**August 10, 2021
7:00 PM
Planning Board Agenda**

City of Beacon Planning Board Agenda
08/10/2021

Public hearing on application for Special Use Permit and Site Plan Approval, accessory apartment, 1 Wilson Street, submitted by Jon Moss

GRADING & UTILITY PLAN

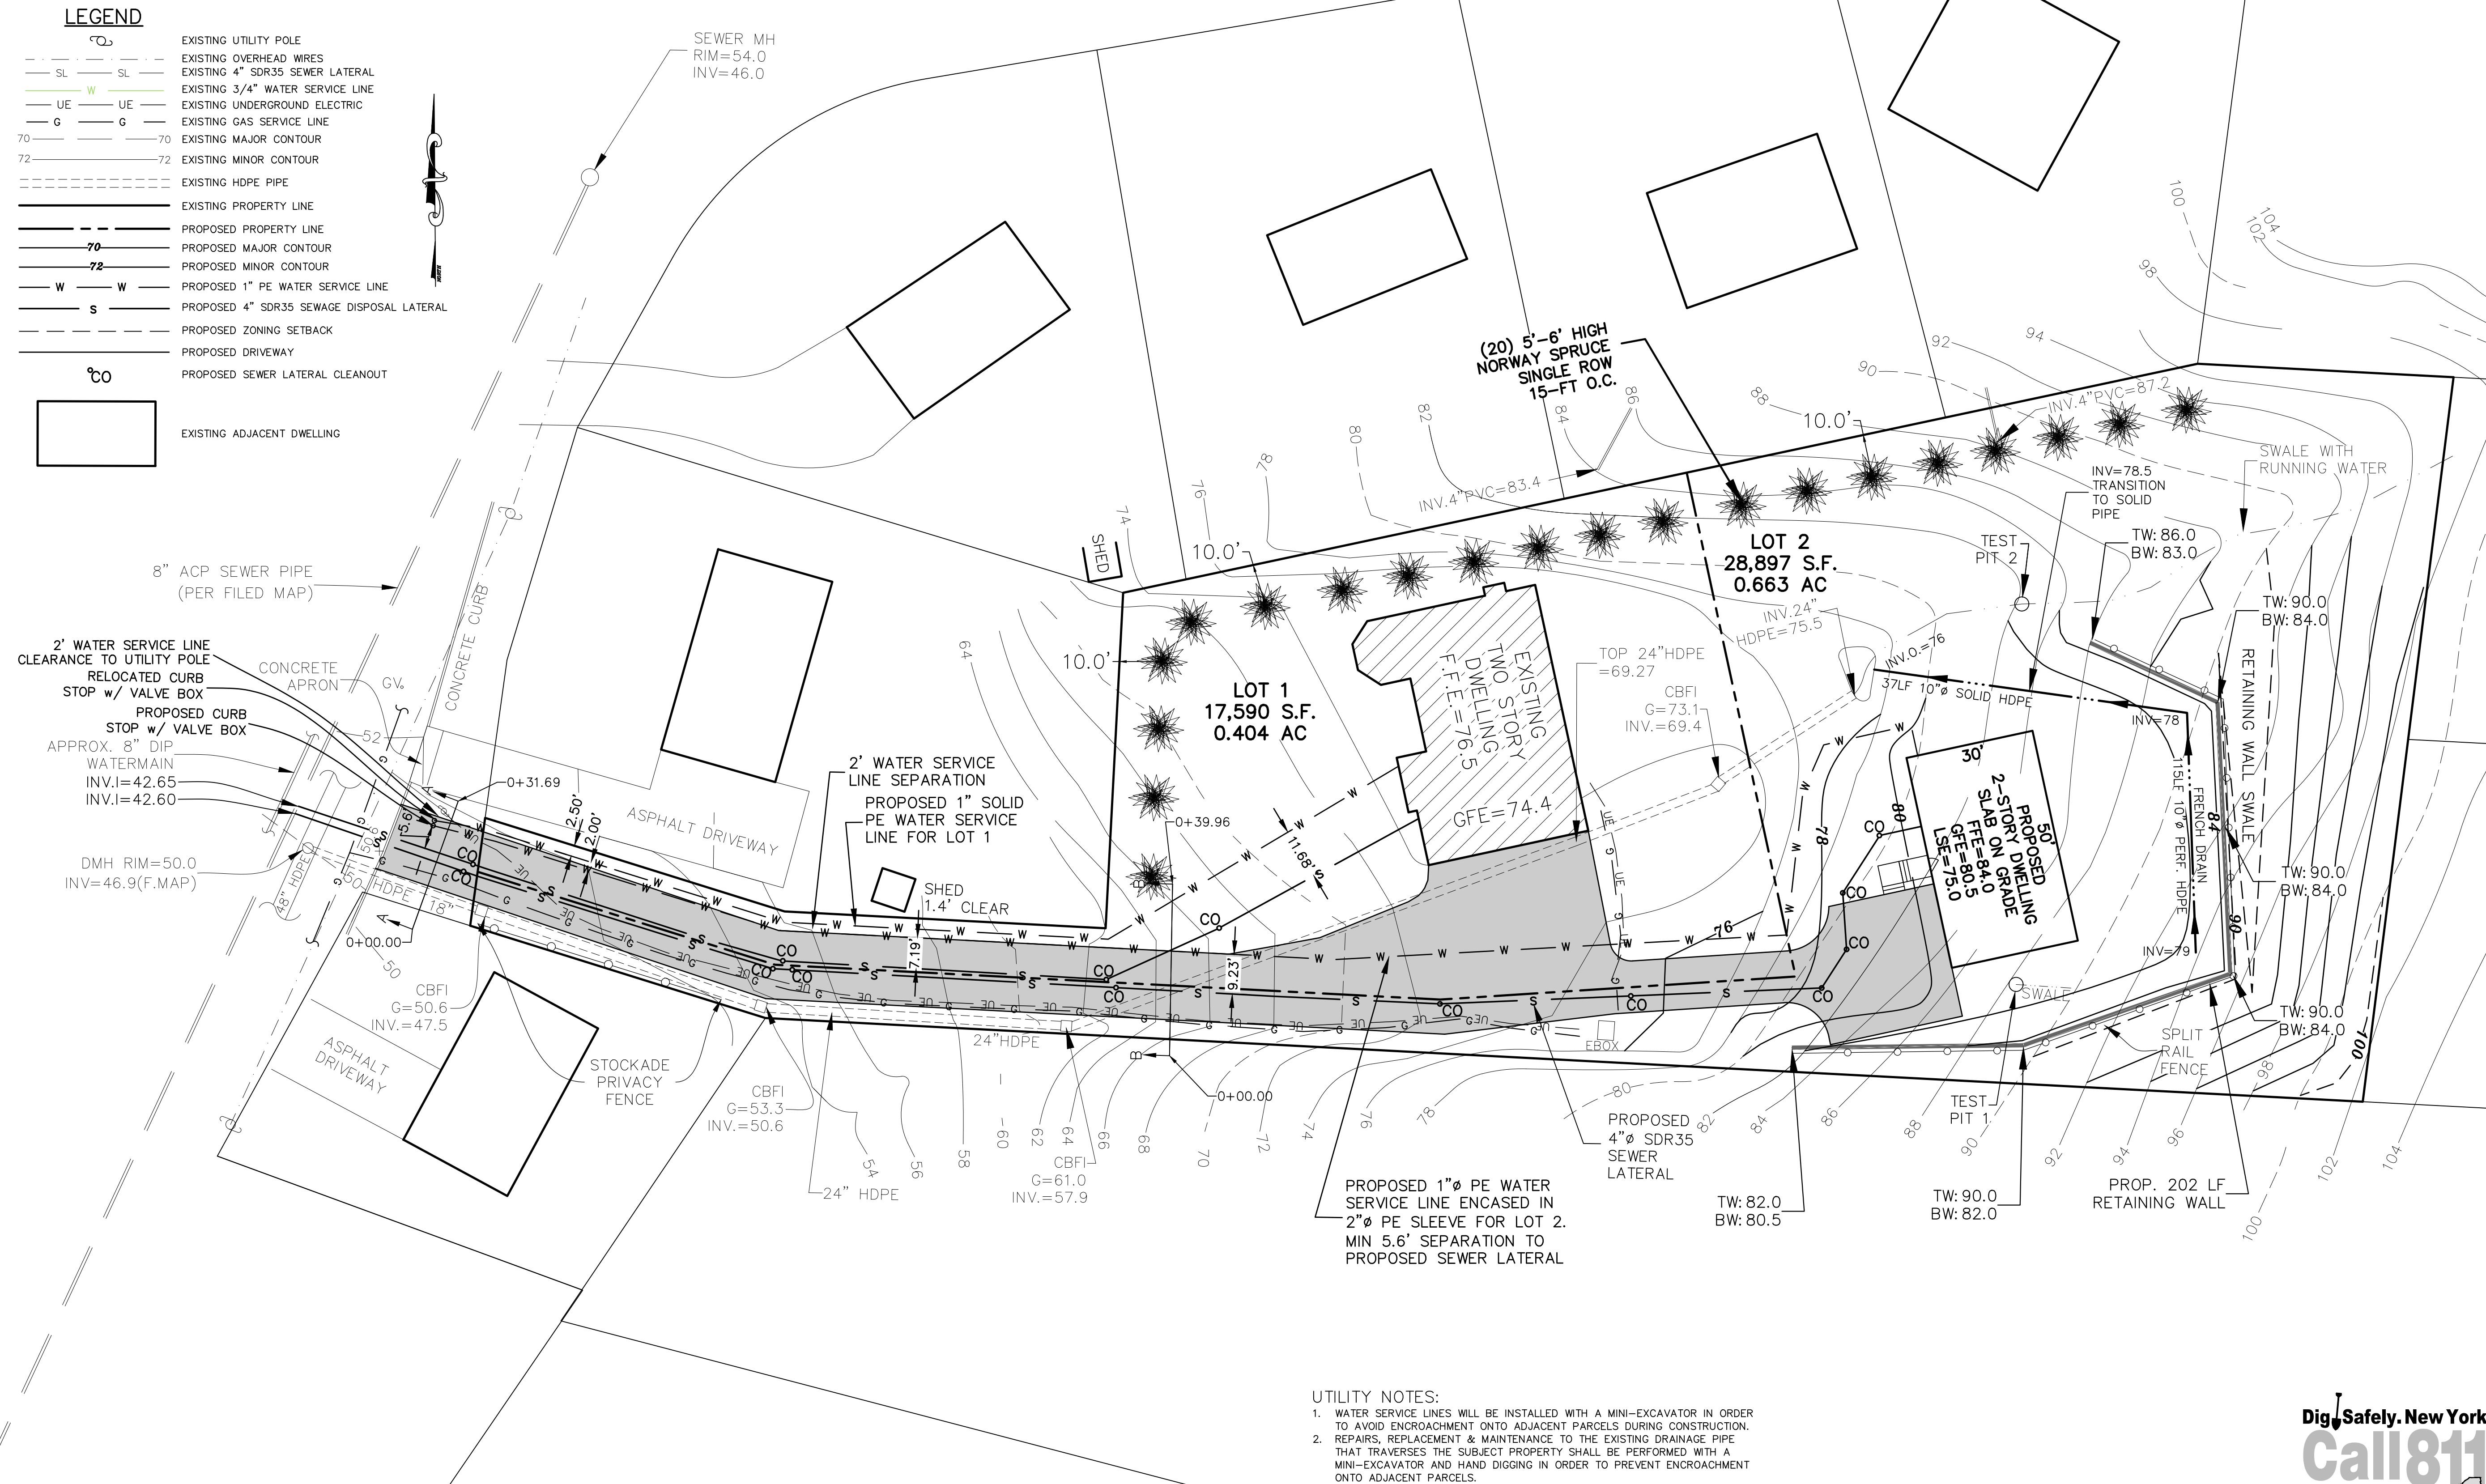
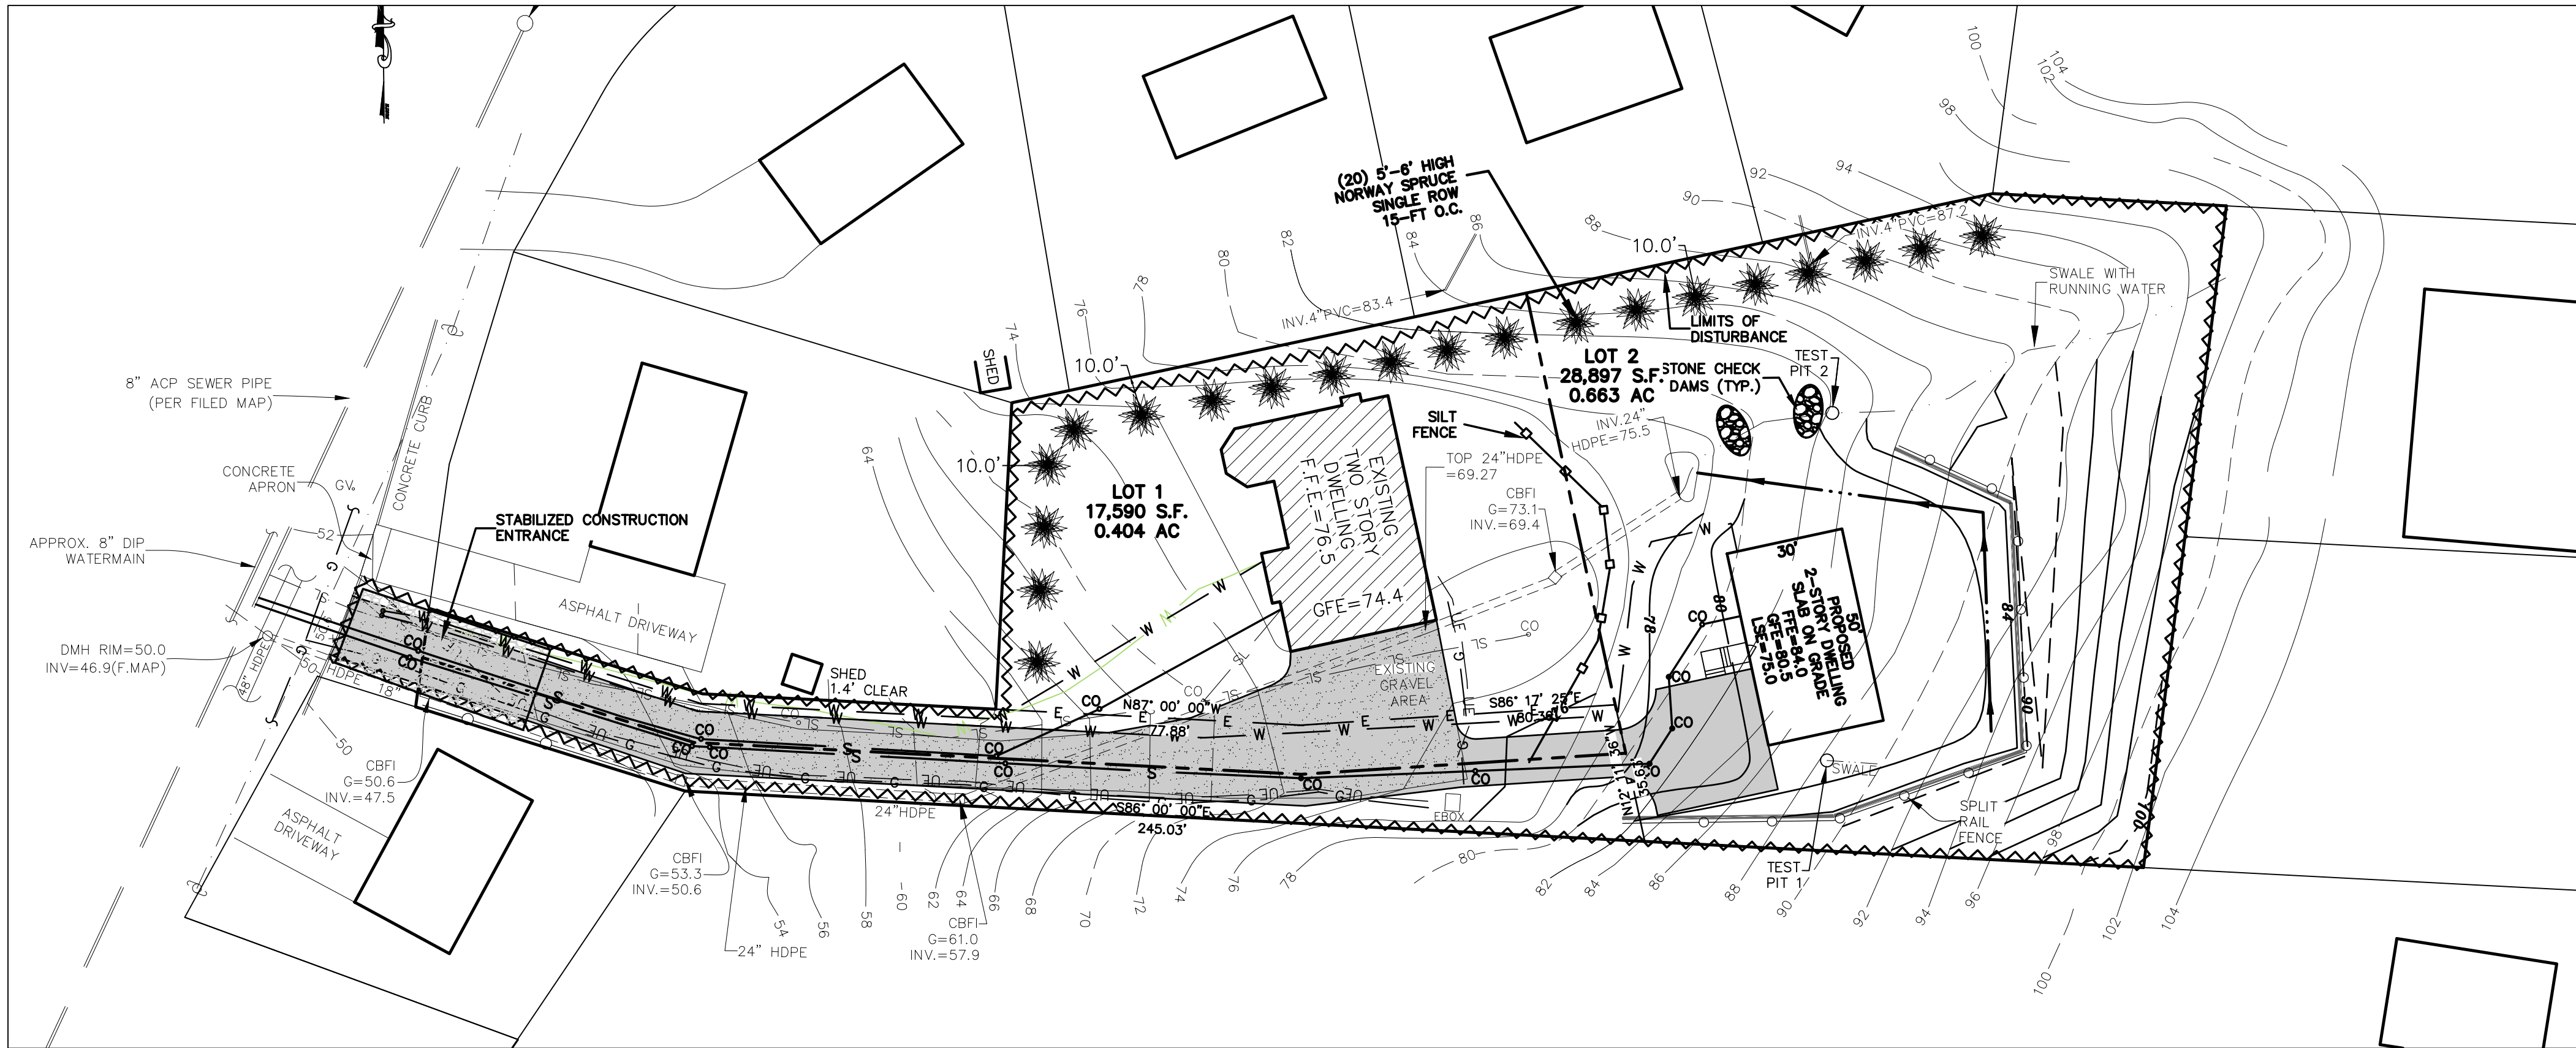
6. Sheet 4 of 6, Grading & Utility Plan: The curb box, water valve, and service line for the water service to Lot I should be located further away from the existing utility pole so that the utility pole is not compromised when digging next to the pole. We would further recommend this relocation so that in the event the pole is removed, it does not compromise the water service line.

7. Sheet 4 of 6, Grading & Utility Plan: It is unclear as to how the water service line for Lot I will be installed without encroaching on to the neighbor's parcel with equipment to allow for excavation of the trench since it is approximately 1 foot off the property line. The water service should be shifted further away from the property line, or a construction easement obtained from the Lamb parcel to allow for the installation of the service line.

8. Sheet 4 of 6, Grading & Utility Plan: The storm drainage line running along the south side of the driveway along the DeCampo parcel is within 1-foot of the property line. In the event that this line needs to be excavated to allow for repair or replacement, how will this be accomplished without encroaching on the neighbor's parcel?

9. Sheet 4 of 6, Grading & Utility Plan: The location of the front door and stairs required to entire the proposed residence on Lot 2 should be provided on the plan. There is a 3.5-foot grade change from the grade on the exterior of the proposed residence to the first-floor elevation.

Response: Pursuant to the notes added to Sheet 4, the water service line will be installed with a mini-excavator in order to avoid encroachment onto adjacent parcels during construction.

Response: Pursuant to the note added to Sheet 4, repairs, replacement, and maintenance to the existing drainage pipe that traverses the Premises shall be performed with a mini-excavator and hand digging in order to prevent encroachment onto adjacent parcels.

Response: The front door and stairs for the proposed residence have been added to Sheet 4.

1 GRADING PLAN
SCALE: 1"=30'

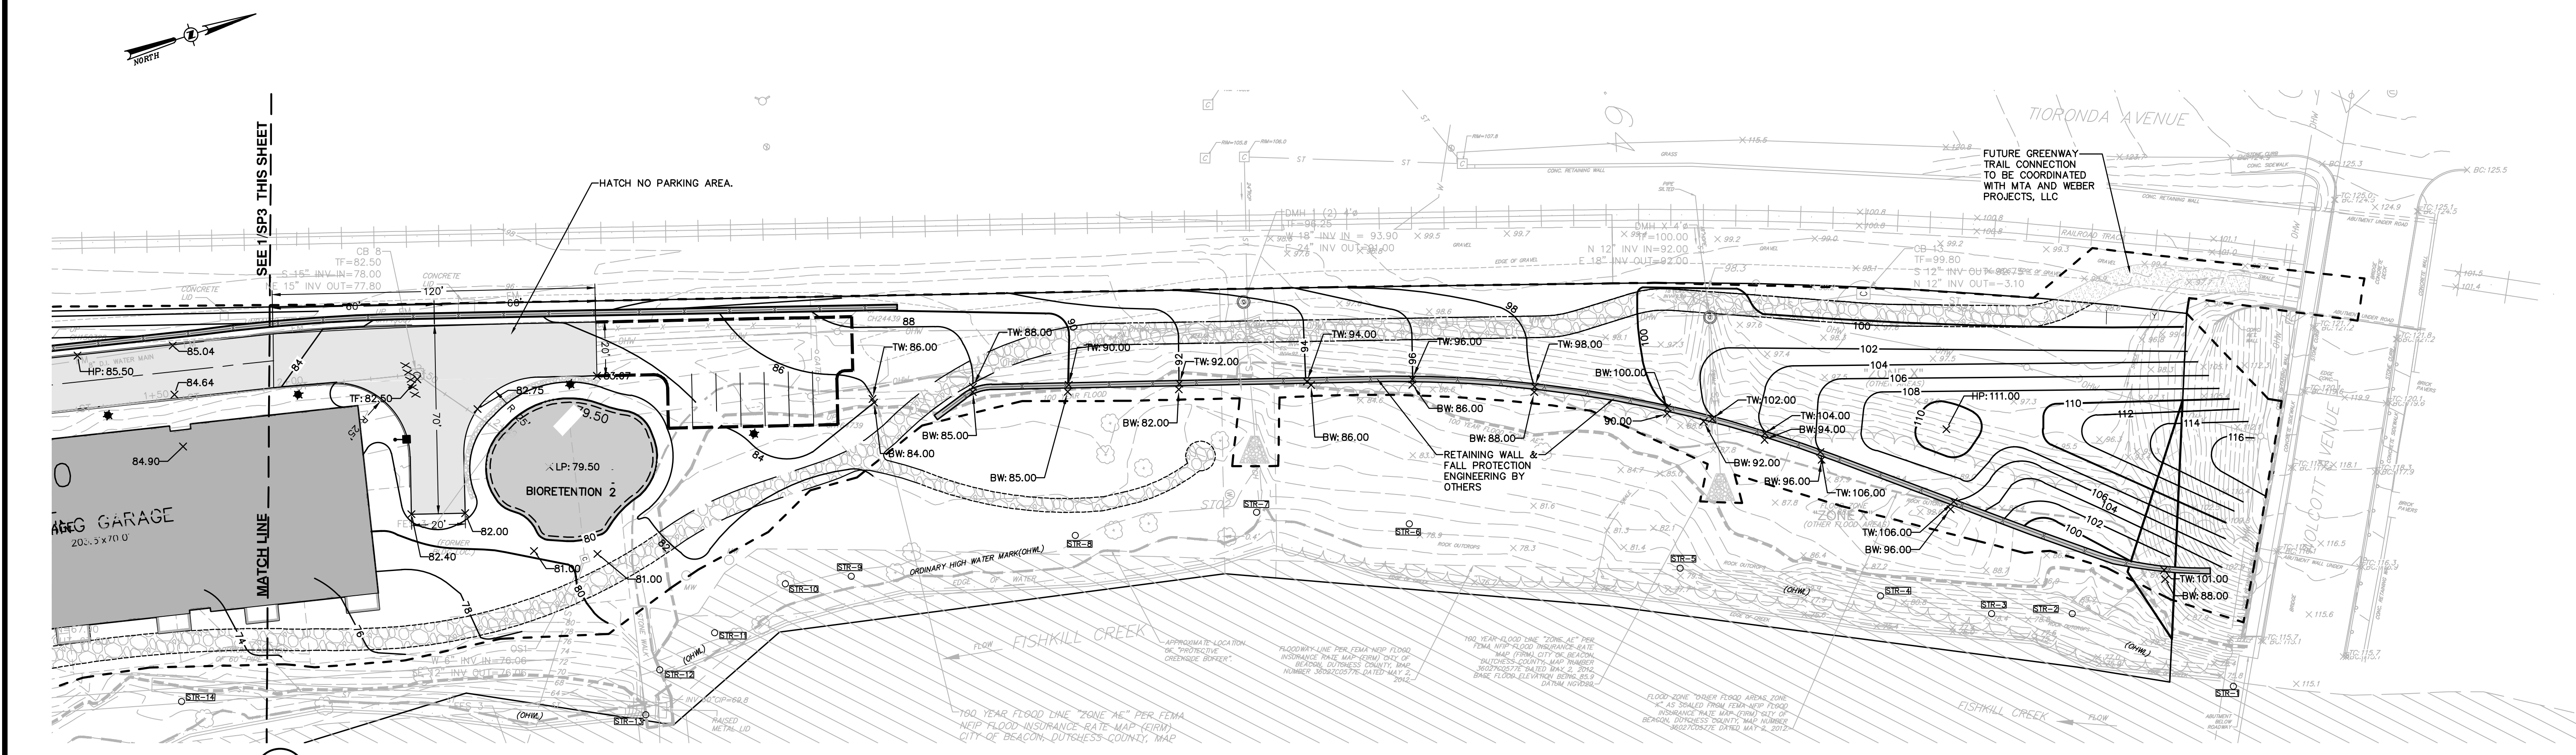
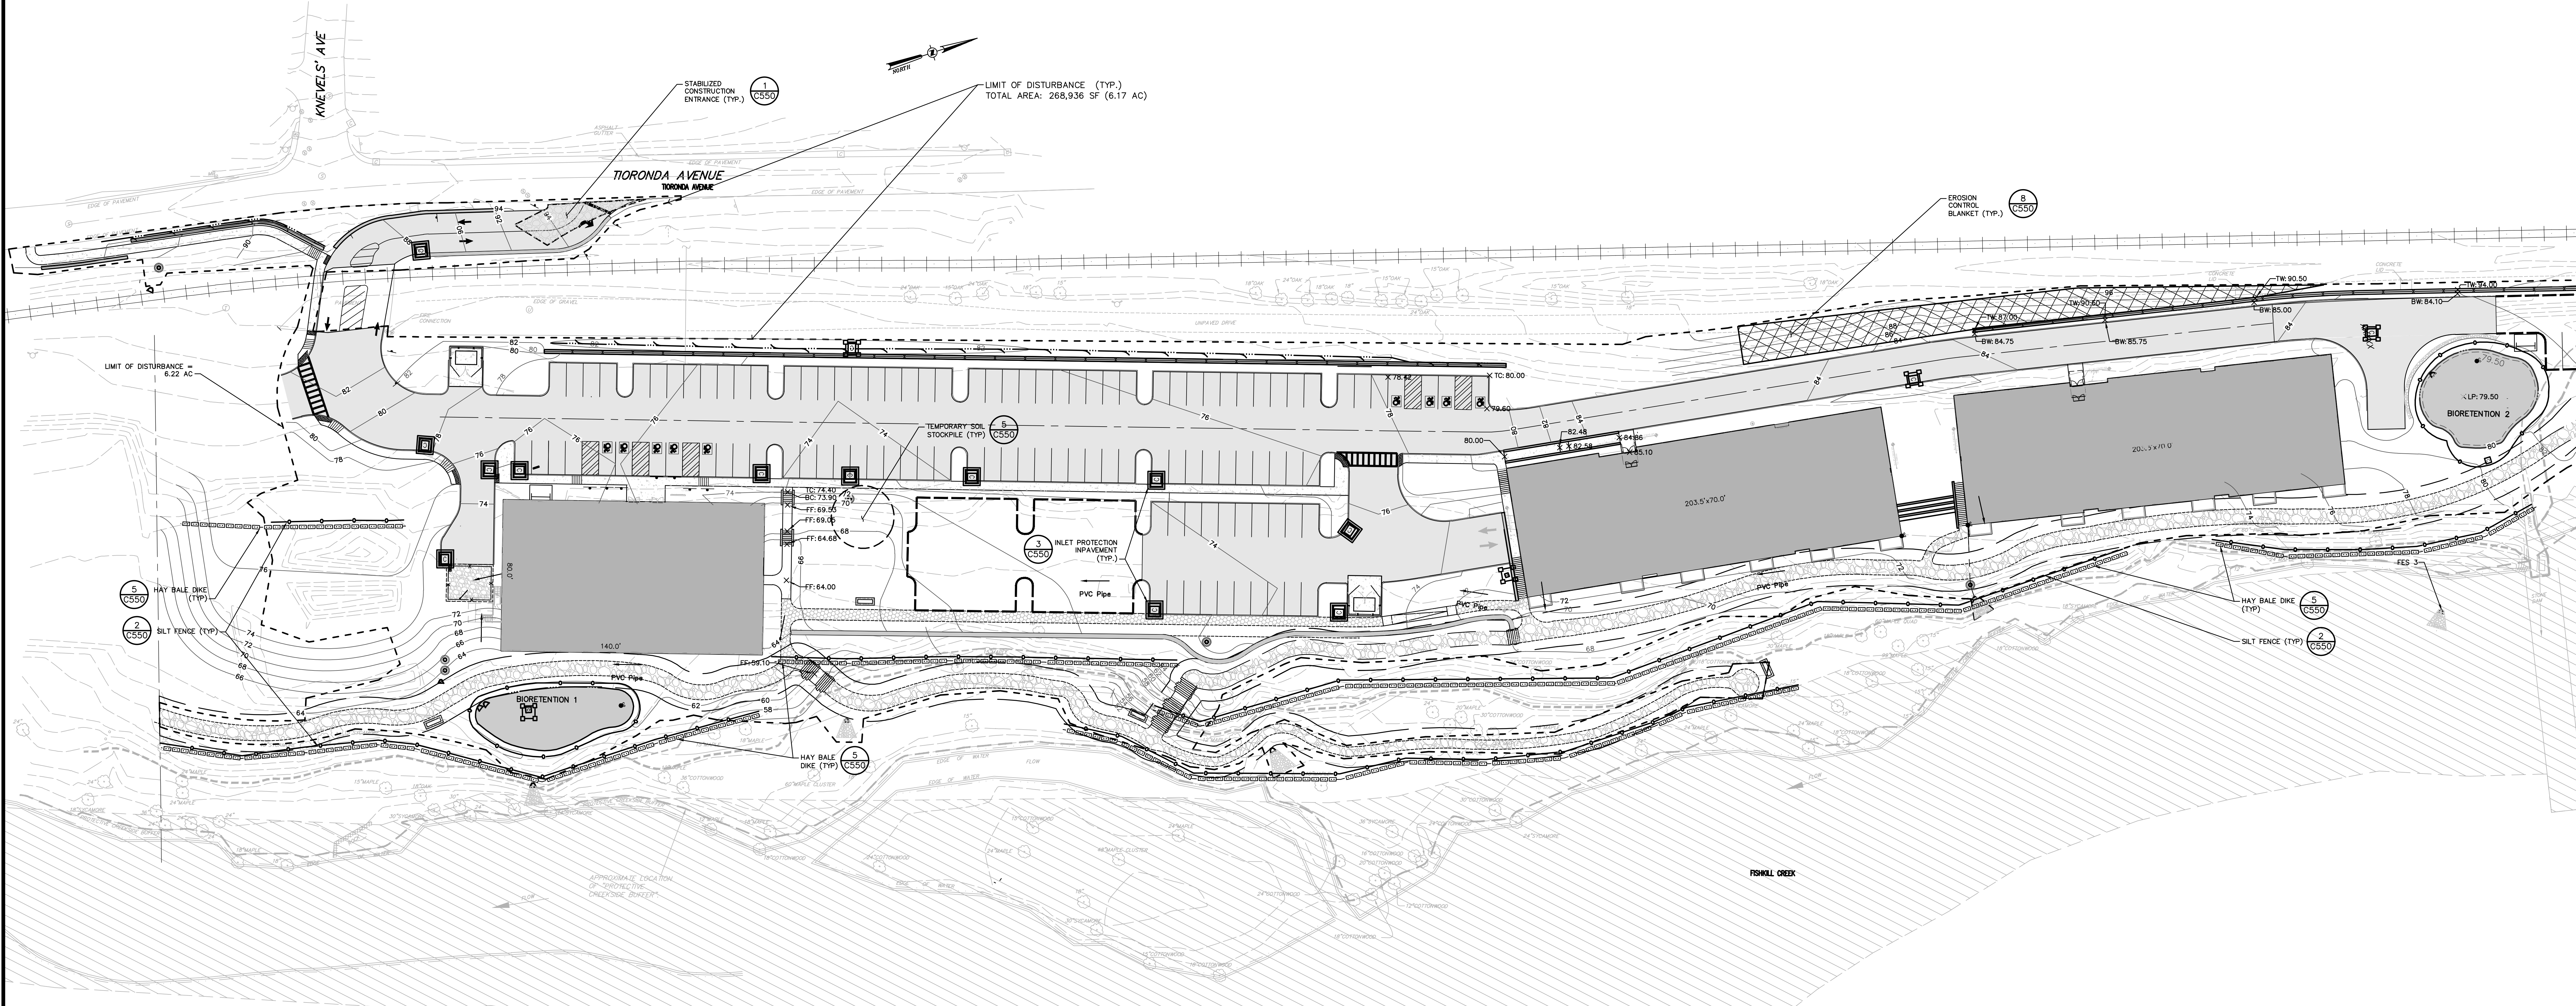
6. On Grading Plan Sheet C140:
 - a. Top and bottom wall elevations shall be provided on the proposed retaining wall located to the west of Building 300.
